Consumer Knitex Limited (CMT Bangladesh) (Extension)

23 February 2025

2. Observations:

Observation-4: Mismatch between drawing & onsite condition (Shed -04 (Knitting production 2)).

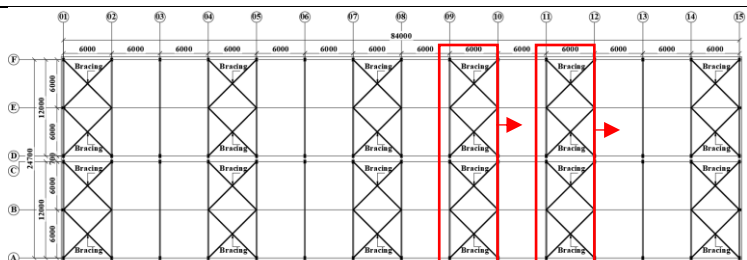
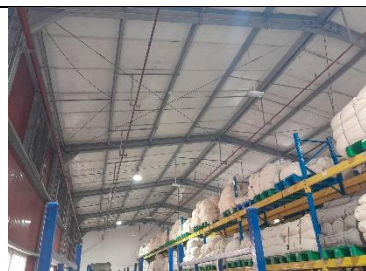
Description: During inspection, steel rafter and column size were found (F 3x150) x (W 3x300) instead of (F 4x150) x (W 4x300).

The building engineer is required to update the drawing based on the as-constructed structure.

Observation 7: Lack of lateral stability, distorted truss and improper connection. (Shed -07 (Empty Chemical drum store))

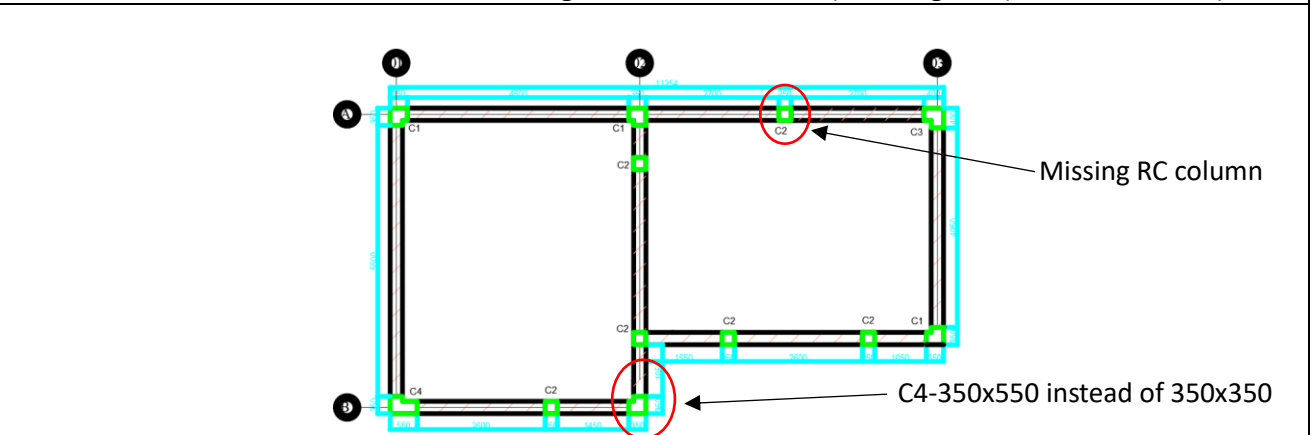
Description: Lateral load transfer media is not provided to transfer the lateral load. Also, improper connection and a distorted truss were observed in the roof shed. The building engineer is required to check the lateral stability and connection adequacy of the shed and prepare the safety check report and as-built drawing.
